THE CITY OF KEY WEST
PLANNING BOARD
Staff Report

Agenda Item: **Variance – 10 Lowes Lane (RE# 00007530-000000)** – A request for a variance to the minimum required front, side, and rear setbacks, and the minimum required open space in order to remodel an existing single-family home on a parcel located within the Historic High Density Residential (HHDR) zoning district pursuant to Section 90-395, 122-630(6)a., 122-630(6)b., 122-630(6)c., and 108-346(b) of the Land Development Regulations of the City of Key West, Florida.

Existing and Proposed Floor Plan

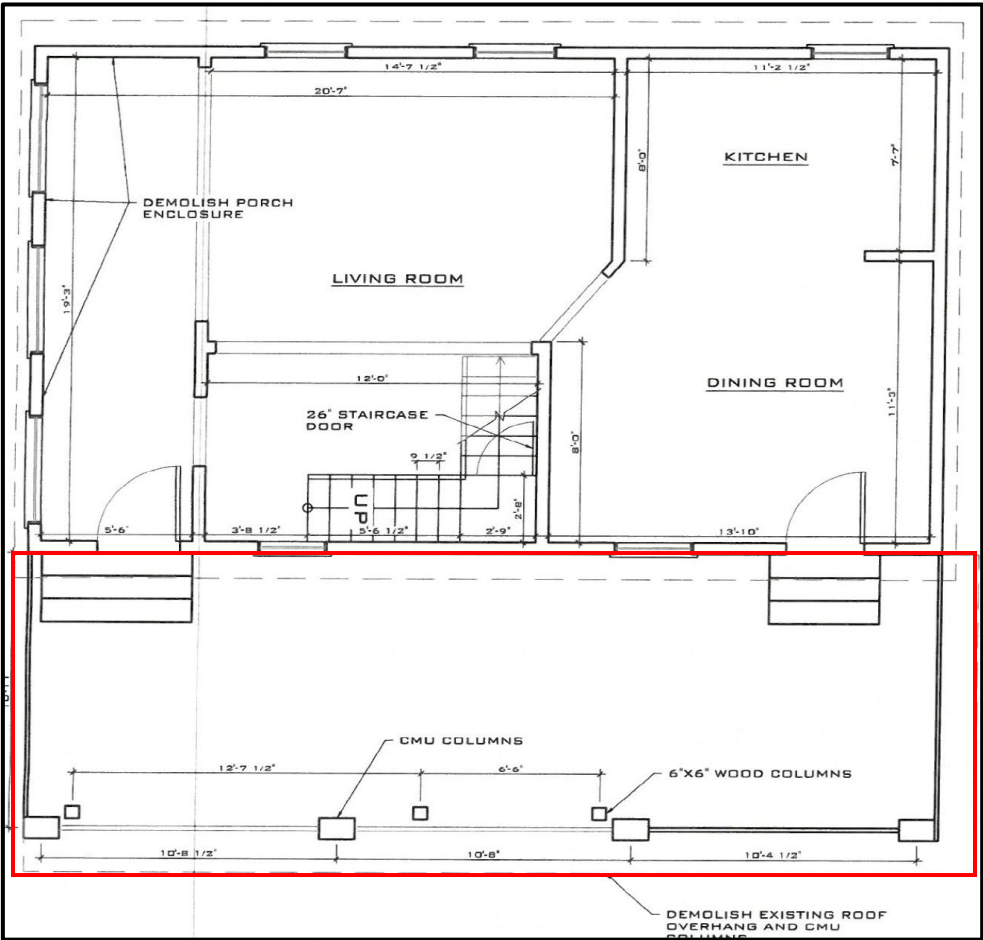
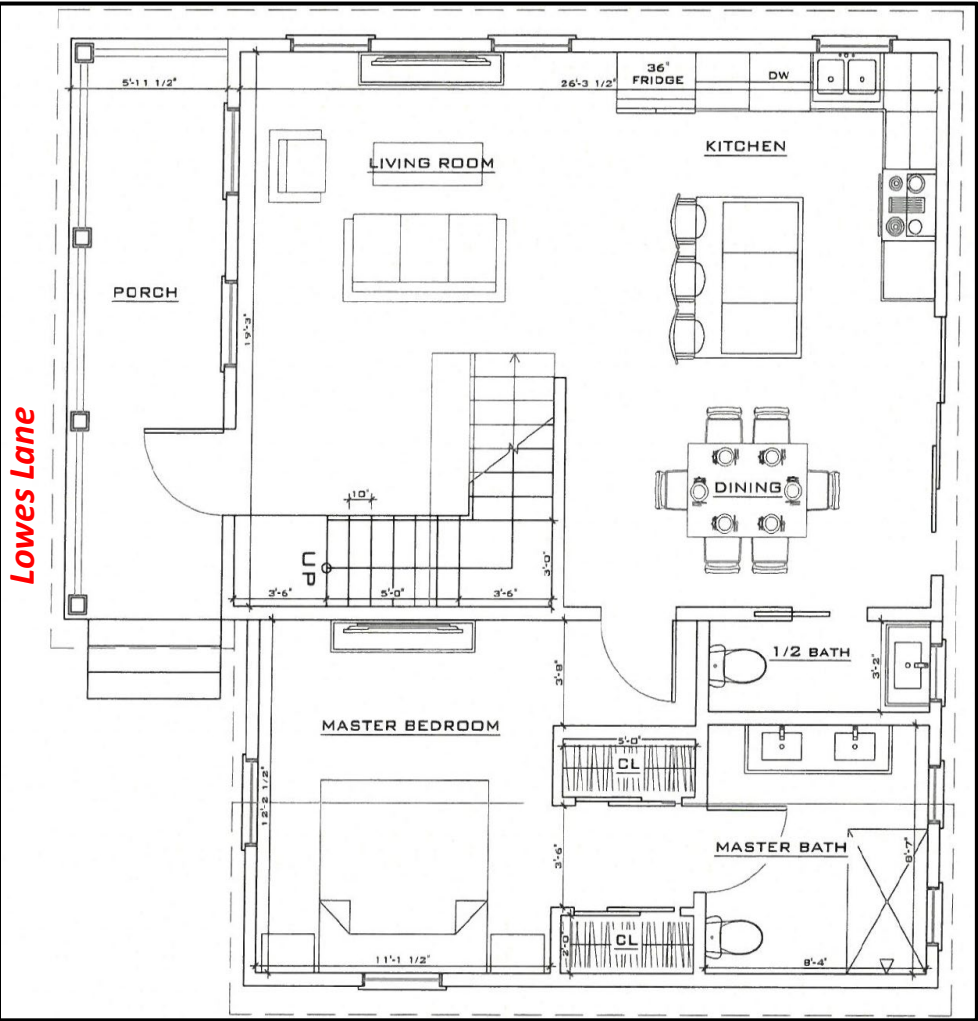
Red square indicates area to be demolished on the first floor.

Proposed first floor plan includes a master bedroom, master bathroom, and 1/2 bath to be constructed within the required front and rear setbacks.

Existing and proposed front elevation

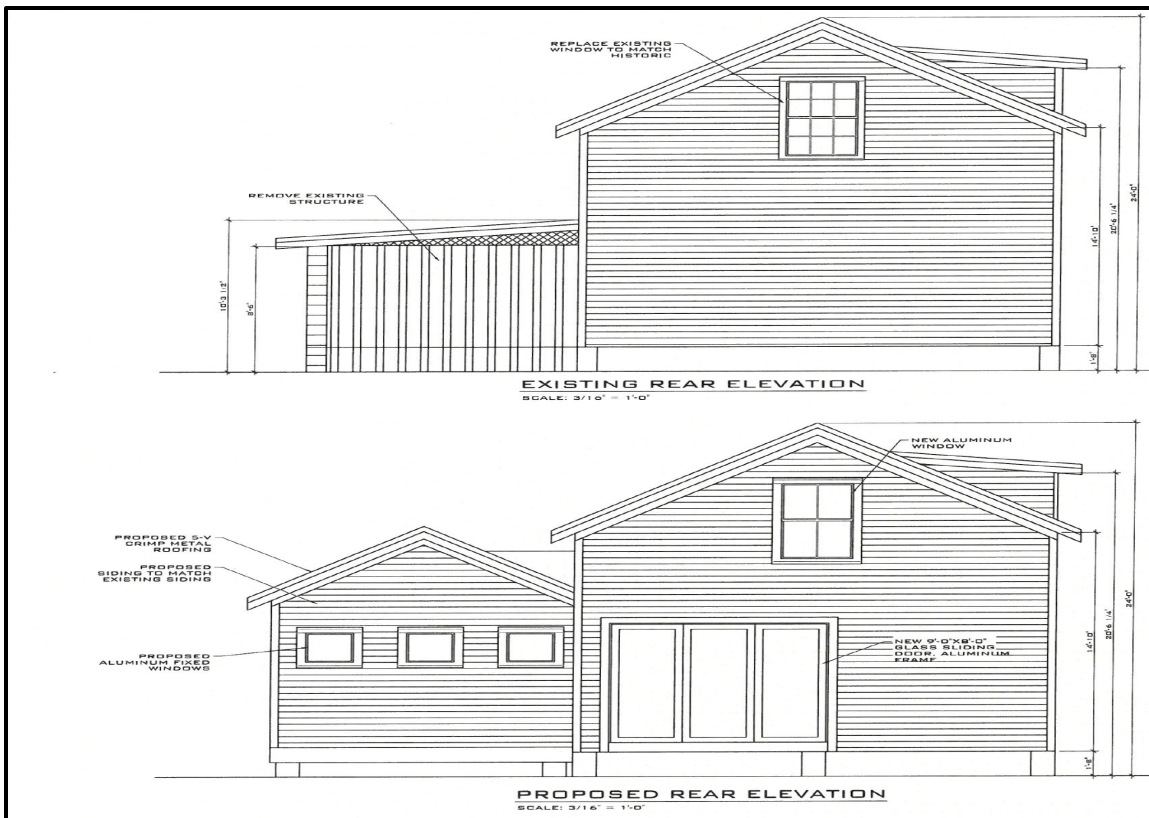
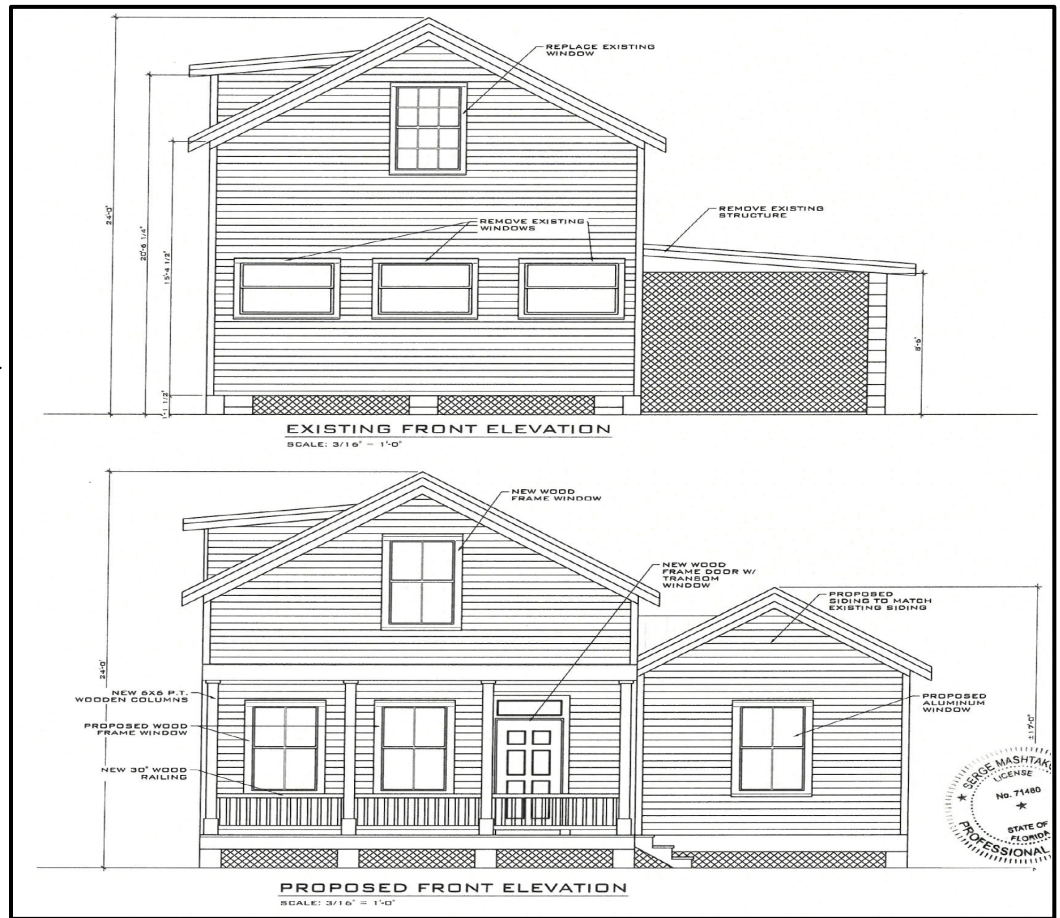
Plans depict existing covered porch will be demolished and reconstructed into habitable space. The front of the structure will be opened up to construct a new porch, though the existing 0'-0" setback and 0.7' overhang over City right-of-way will remain.

Existing and proposed rear elevation

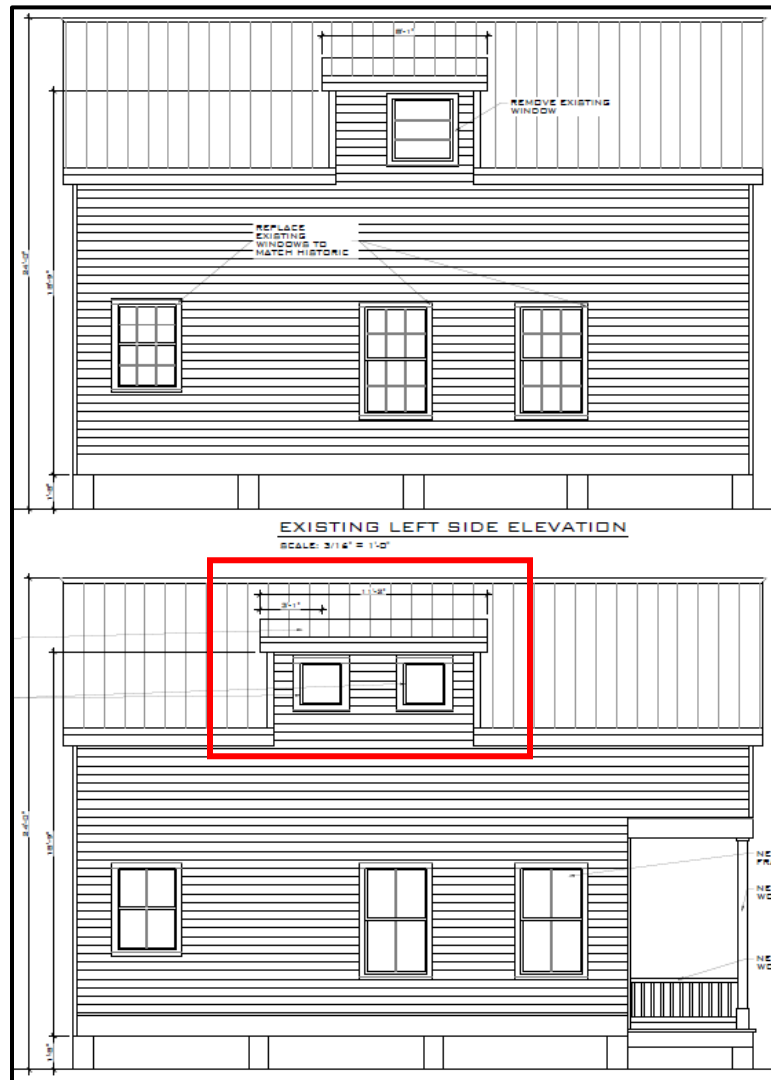
Plans depict new structure elevated 1'-8".
